Type 1 Required MODIFICATION INSTRUCTIONS for Service Codes: 3434 and 3425

Kodak X-Omat 3000 RA PROCESSOR Mod No. 1

Kodak X-Omat 5000 RA PROCESSOR Mod No. 3

To help prevent the possibility of film jams in the FIXER/WASH CROSSOVER, due to swelling of the ROLLER, and to install the latest version of software.

Figure 1 3000 RA PROCESSOR, Replacement of the "A" ROLLER — See Page 4 for the 5000 PROCESSOR

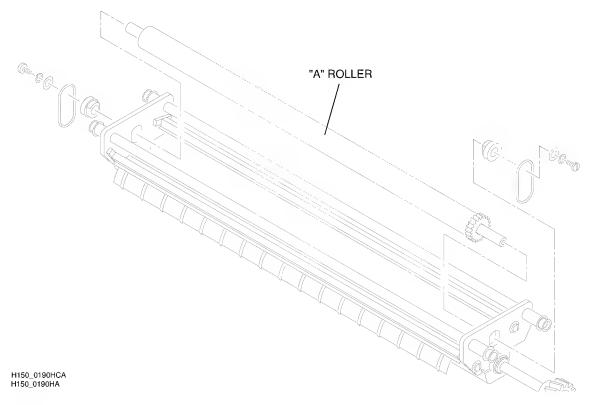
- 1. Remove the existing "A" ROLLER from the FIXER/WASH CROSSOVER.
 - See Figure 1 for the 3000 RA PROCESSOR on Page 3.
 - See Figure 2 for the 5000 RA PROCESSOR on Page 4.
- 2. Install the new "A" ROLLER from the Mod Kit.

ROLLER 9B8662 does <u>not</u> substitute for 467017 in all positions in the 3000 and 5000 PROCESSORS, only in the "A" position of the FIXER/WASH CROSSOVER.

Old	New		3000 RA Processor	5000 RA Processor	
Part No. Part No.		Description	Affected Pages	Affected Pages	
467017	9B8662	"A" ROLLER - FIXER/WASH CROSSOVER	2-5, 3-23, 9-4, and	2-3, 3-23, 9-4, and	
		<u>only</u>	10-7	10-6
